Planning Commission Meeting July 6, 2020

**City of Fairhope
Planning Commission Agenda
5:00 PM
Council Chambers
July 6, 2020**

Exchange:	251928
Designer:	Mitchell,Wade
Phone:	251-471-8361
Authorization:	OAN00205N
Dwg. <u>3</u> of <u>11</u>

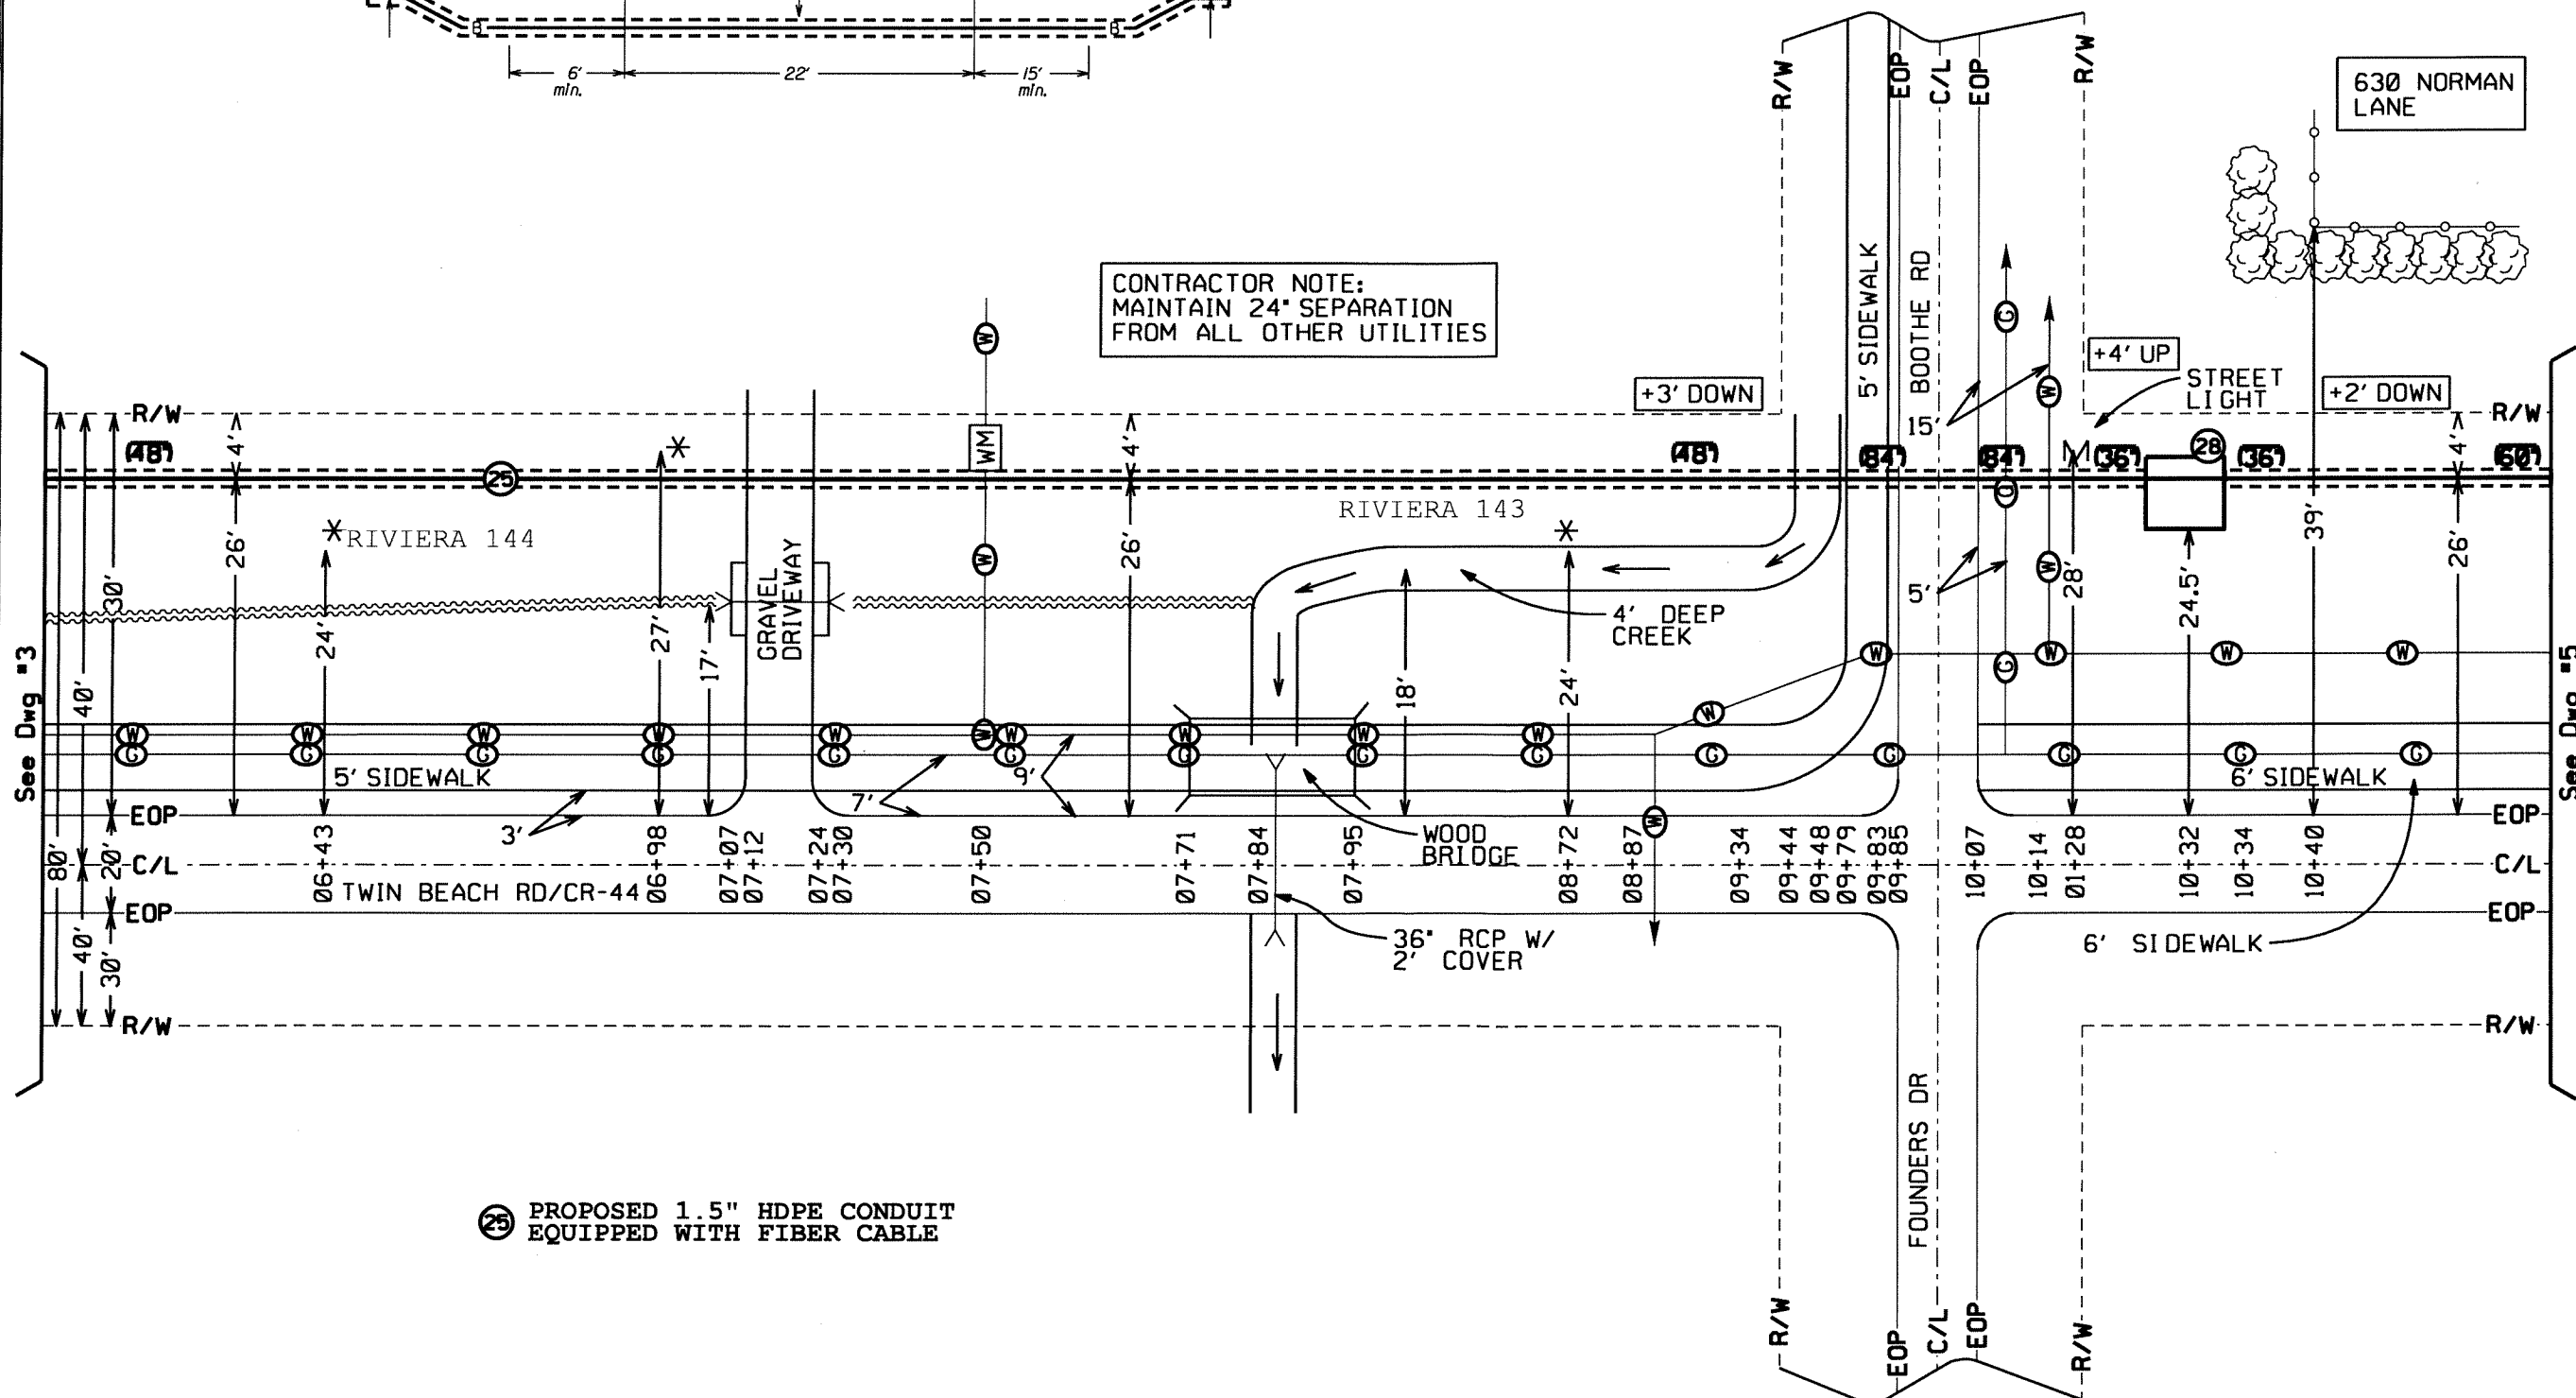
2. Edit the note on drawing 4 of 11 to reflect 36" separation from all drainage and utilities
3. At all street crossing locations, conduct potholing to determine exact location and elevation of existing utilities. Reflect the exact elevation of utilities and gps coordinates of the pothole locations on a set of as-built drawings.
